Subject: POPPING AND/OR SQUEAKING NOISE FROM FRONT SHOCK ABSORBER AND/OR CREAKING NOISE FROM FRONT LOWER ARM BUSHING	Bulletin No: 02-001/16
	Last Issued: 02/23/2016

This bulletin supersedes the previously issued bulletin(s) listed below. The changes are noted below in Red beside the change bars.

Protector Installation

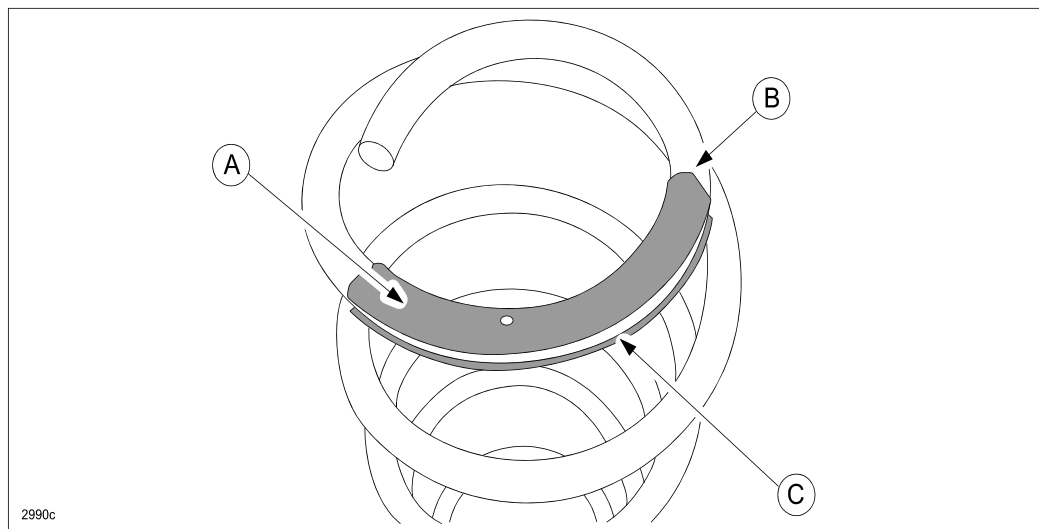
1. Remove the spring according to MS3 online instructions or the Workshop Manual (section 02-13 FRONT SHOCK ABSORBER AND COIL SPRING DISASSEMBLY/ASSEMBLY).
2. Degrease 1.5 turns of the spring from the top.
3. Cut a thin strip of paper to 138 mm in length (or use a cloth type measuring tape).
4. Place the strip of paper (or cloth measuring tape) along the inner side of the coil spring starting at point (A) and mark the spot on the spring where (B) is. (B) is the starting point for the protector installation.

5. Install the protector (A) onto the coil spring aligning the end (slant cut side) with the marking at spot (B).
NOTE: Install the protector so the gap (C) is evenly aligned around the outer edge of the coil spring.

Bump Stopper Replacement

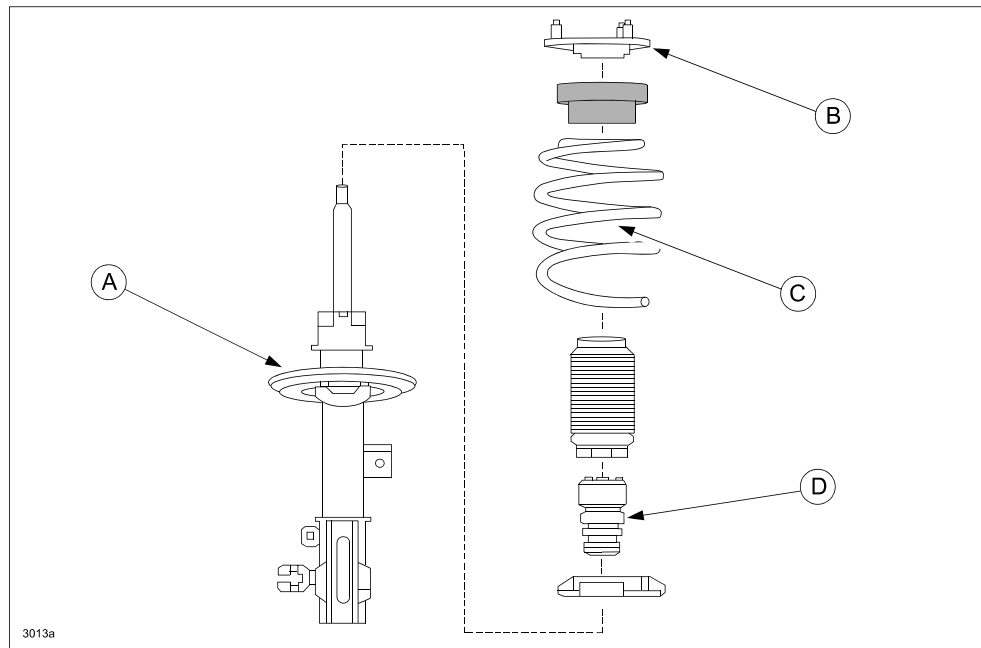
1. Replace the bump stopper with the modified one according to MS3 online instructions or the Workshop Manual (section 02-13 FRONT SHOCK ABSORBER AND COIL SPRING DISASSEMBLY/ASSEMBLY).

- Before removing the mounting rubber, mark its original position so it can be re-installed later to the same position.
- When replacing the bump stopper with a modified one, apply grease to upper side of the bump stopper and to the inside of the bump stopper (on the surface that contacts the damper rod).

CAUTION: It is not necessary to adjust the front wheel alignment because the front shock absorber and mounting rubber are not being replaced. However, make sure to install the mounting rubber to the original position.

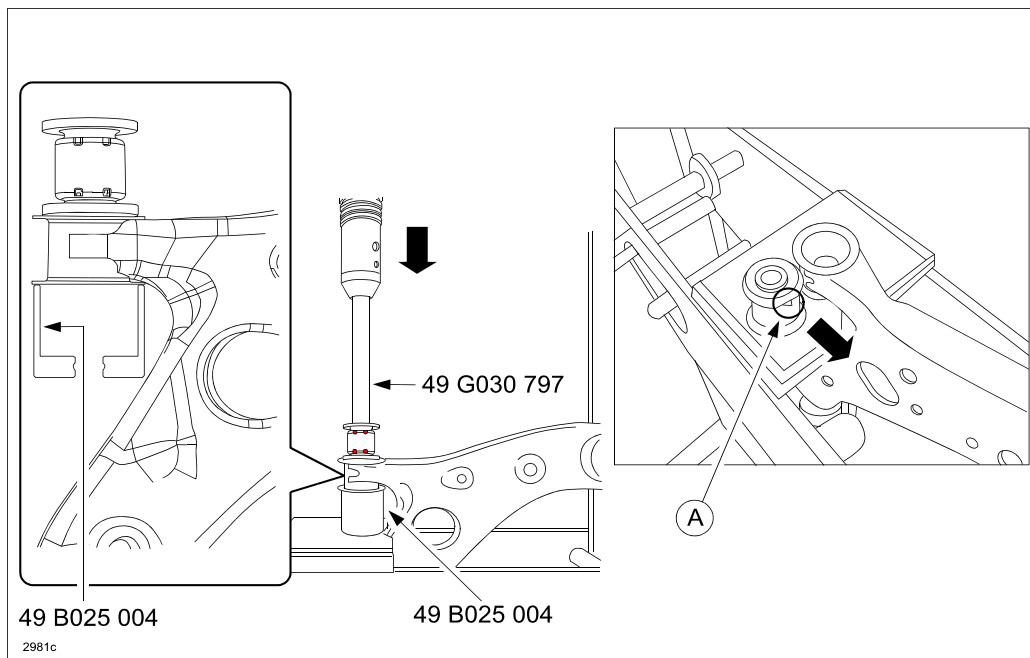
- Before installing the new bushing, wipe the inside of the outer tube and make sure it is clean.
- Apply soap suds to the bushing to ease the installation.
- Always wipe off soap suds from the front lower control arm and bushing with a cloth.
- Install the bushing so the projection (A) is pointing toward the front of the vehicle.

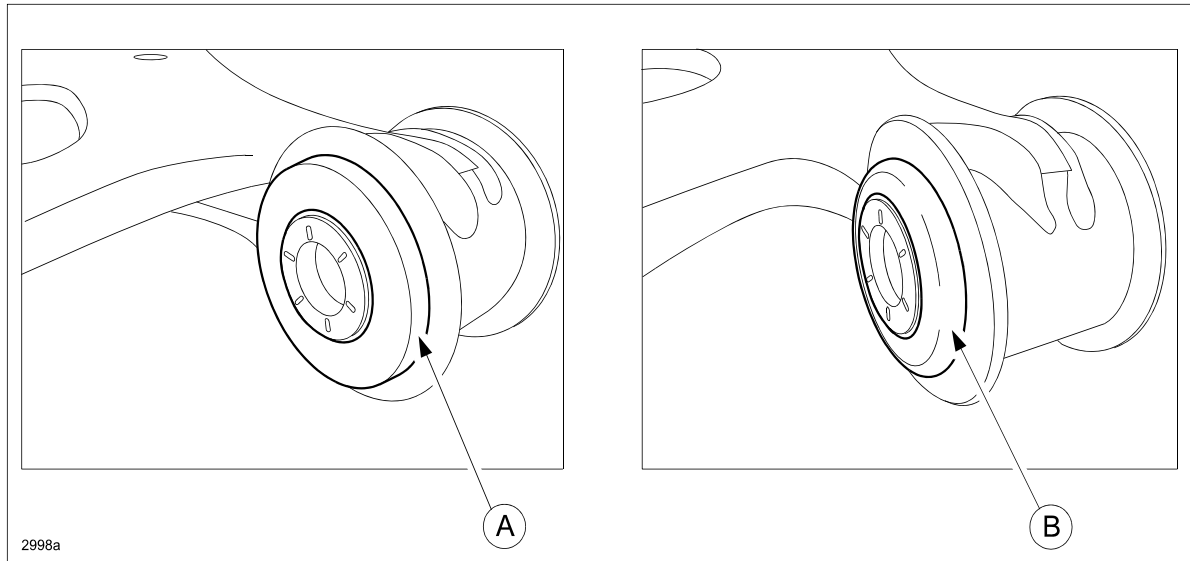
CAUTION: Make sure the bushing has been properly inserted by verifying that the bushing tab **IS FULLY EXPANDED**, as shown in the illustration to the left (A). The illustration to the right (B) shows an example of a bushing tab that **IS NOT FULLY EXPANDED**.

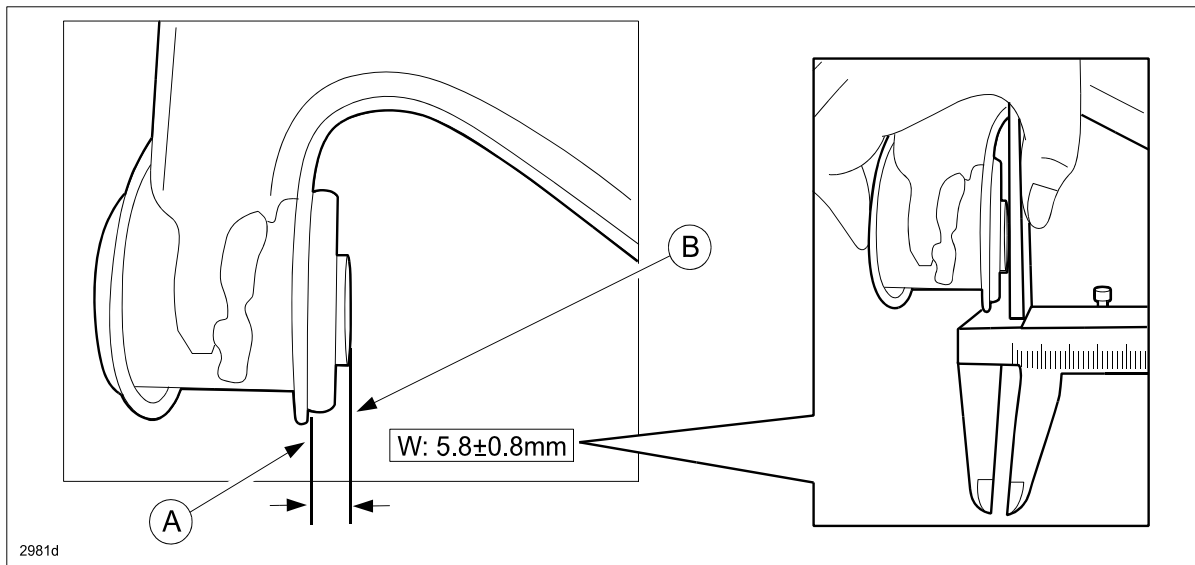
5. After installing the bushing, verify the distance between the front lower control arm (A) and front lower control arm bushing inner pipe (B) equals $5.8 \pm 0.8\text{mm}$ as shown below.
